SANDY CITY COMMUNITY DEVELOPMENT

Staff Report Memorandum

To: Planning Commission
From: Community Development Department
Subject: Sequoia Cove Subdivision (Preliminary Review & Special Exception Requests)
1368 E. Coppercreek Rd.
(Community #16, Falcon Park)

SUB11142025-007080
SPX12172025-007095
R-1-8 Zone
1.029 Acres, 5 New Lots

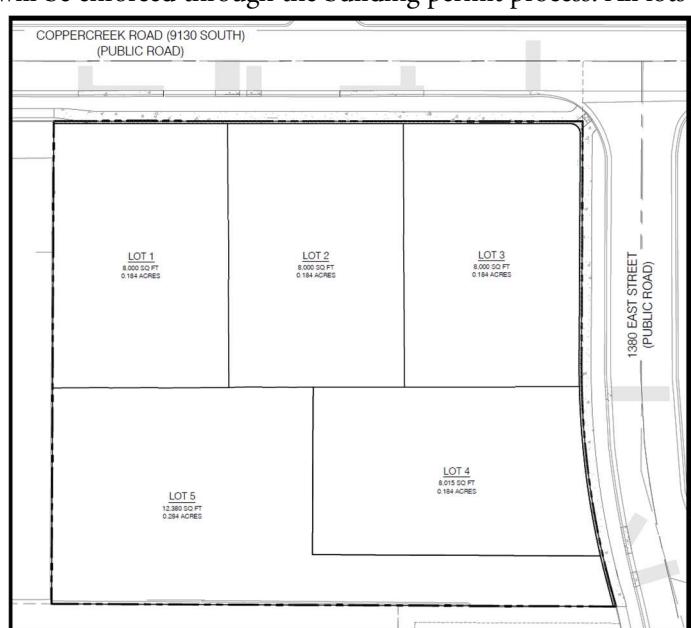
The applicant is proposing the creation of a five-lot single-family residential subdivision on approximately one (1) acre of land. Four (4) of the five (5) lots will directly front onto public streets while an additional lot will be configured as a flag lot in the southwest corner of the property with a staff portion that will connect with 830 East.

All design elements, setbacks, and building height regulations will be enforced through the building permit process. All lots conform with the lot size and frontage requirements of the underlying zoning district after taking the flag lot configuration into account.

The Silvercrest Park 1 subdivision plat was approved and developed in the early 1970's. The street improvements around this property were installed at that time and conformed to existing code which consists of five (5) foot parkstrips with four (4) foot sidewalks. Sandy City's current standard specifications require a minimum five (5) foot sidewalk width. The developer is proposing to dedicate an additional foot on either street frontage for the eventual widening of these sidewalks. The city Engineer has reviewed this proposal and finds it acceptable based on the precedent established in the neighborhood. This will require a special exception to allow for this deviation (see [section 21-21-10\(n\)](#)).

Response to 1-3: The staff portion of the flag lots is 20 feet wide and 120 feet long, which meets this requirement.

Response to 4: The frontage of the flag lot will be considered 830 East, a dedicated public street.

Response to 6: The body portion of the flag lot consists of 9,747 square feet which meets this requirement.

Response to 8 and 9: The proposal is for the creation of a single flag lot which represents 20 percent of the total number of lots within the subdivision.

Staff is concerned about the disposition of the many mature trees within the parkstrips. City code requires that a full tree survey be conducted and reviewed by the City's Urban Forester and Director. The developer will need to provide a plan on how these trees and their root zones will be protected both during and after construction.

Staff recommends that the Planning Commission approve a special exceptions to leave the existing four (4) foot sidewalk in place, and create one (1) flag lot for the Sequoia Cove Subdivision based on the following findings:

1. That the applicant complies with each department's comments and redlines throughout the final review process and that all issues be resolved before the subdivision can be recorded.
2. That the proposed lot sizes and frontages conform to the requirements of the R-1-8 zone.
3. That the applicant works with staff on a tree preservation plan to ensure that all healthy mature trees in the parkstrips are preserved.
